S E R V I C E N O T E

Supersedes:
E8802A-01A

E8802A PNA Series RF Network Analyzers

July 26, 2007

Figure 1

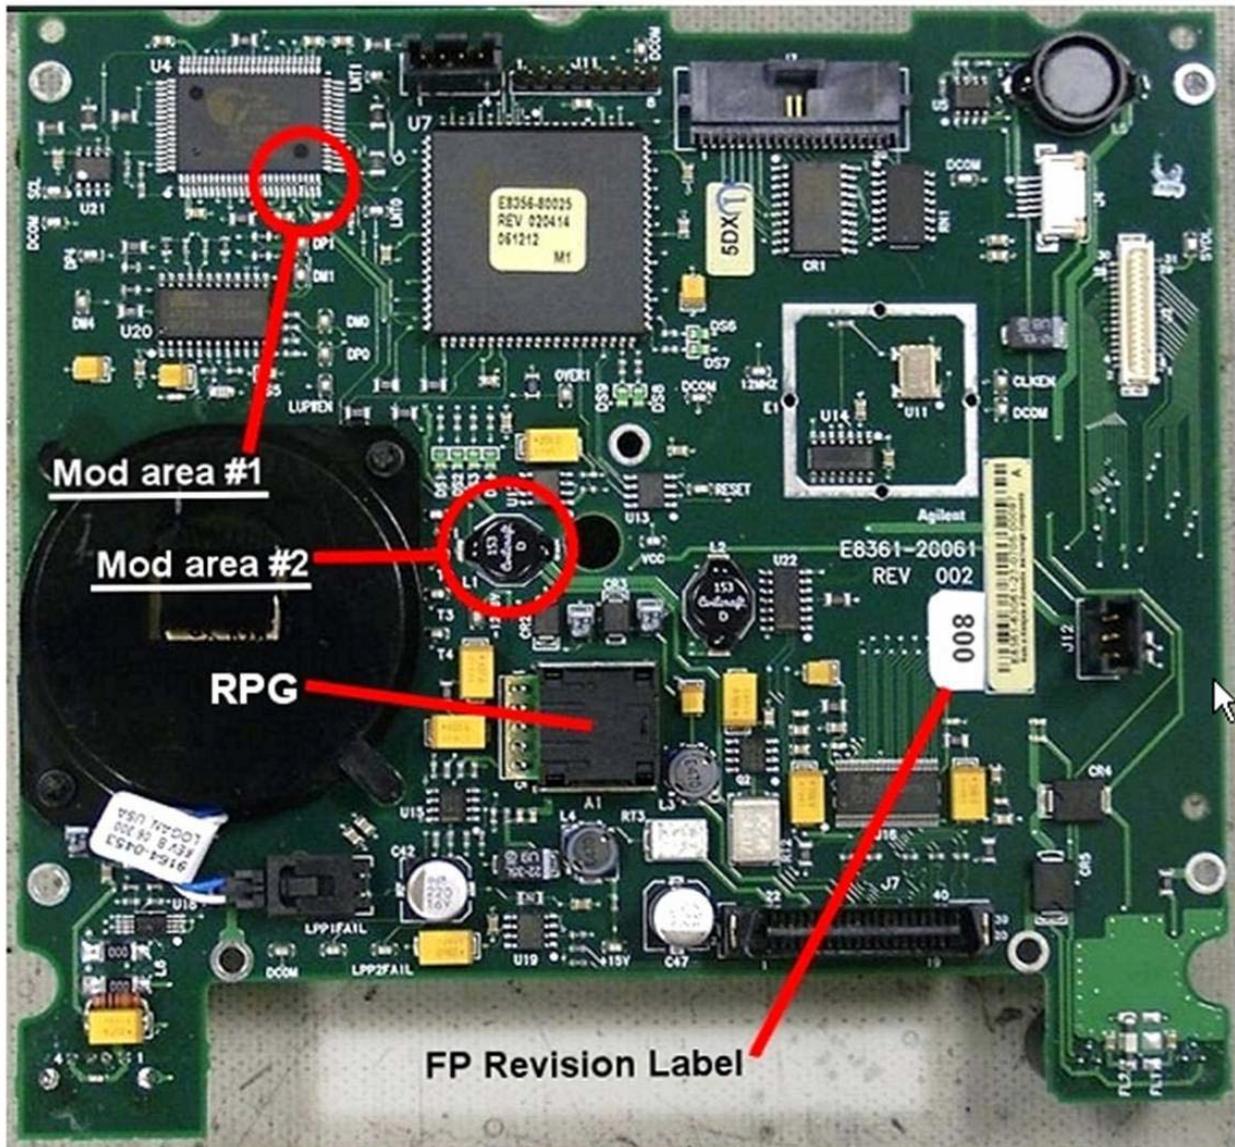
Refer to Figure 1 for the two modification areas to be addressed. Note that while this picture happens to show the FPI board completely removed from the front frame assembly, this is not necessary to perform the required modifications.

- Modification #1 consists of shorting two pins of U4 together with a small amount of solder.
- Modification #2 consist of removing L1.

Figure 2

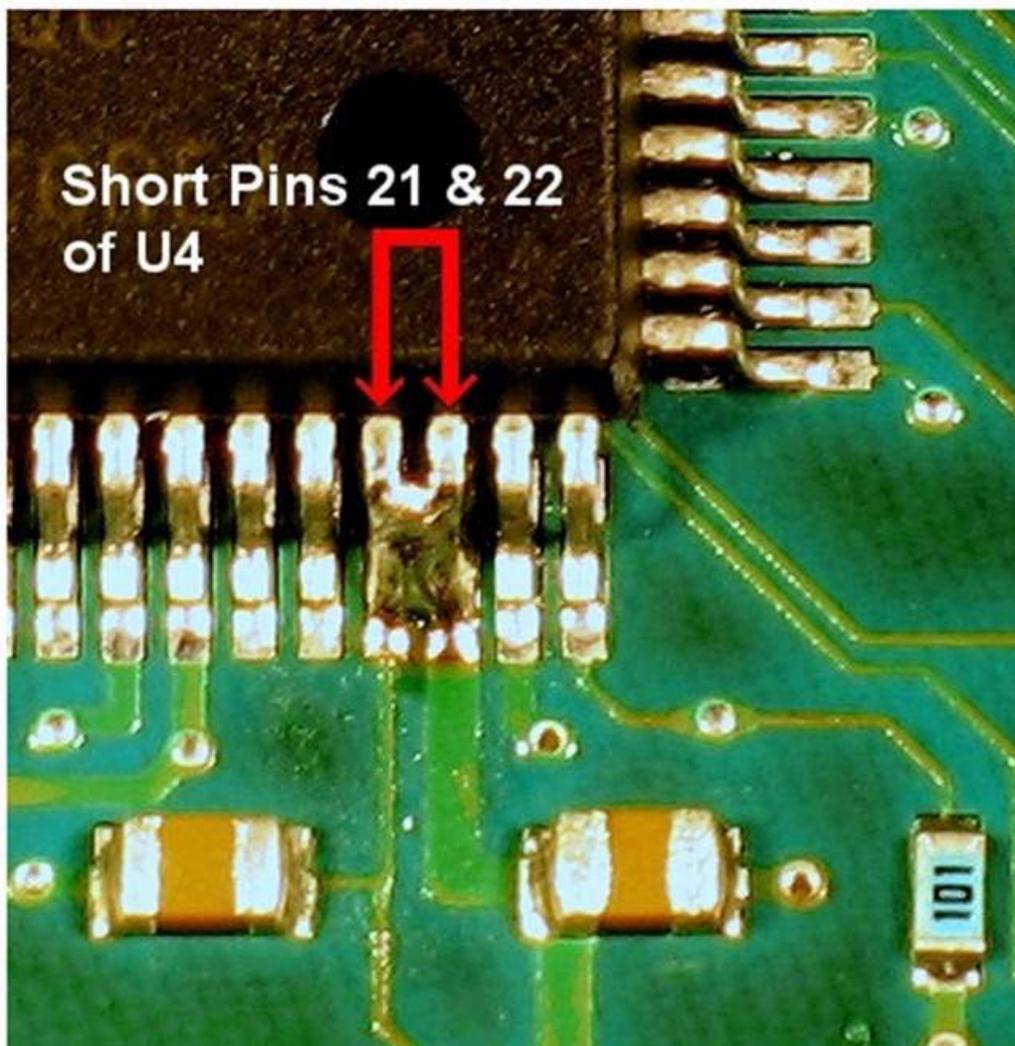
Carefully solder pins 21 and 22 together on U4. Refer to Figure 2 for the exact location. Use care so that no other pins are shorted. Use of a very fine tip soldering iron is recommended and a large work-task magnifying glass is very helpful.

Unsolder and completely remove the black surface mount inductor L1 from the front panel assembly board. This is no longer needed and can be discarded.
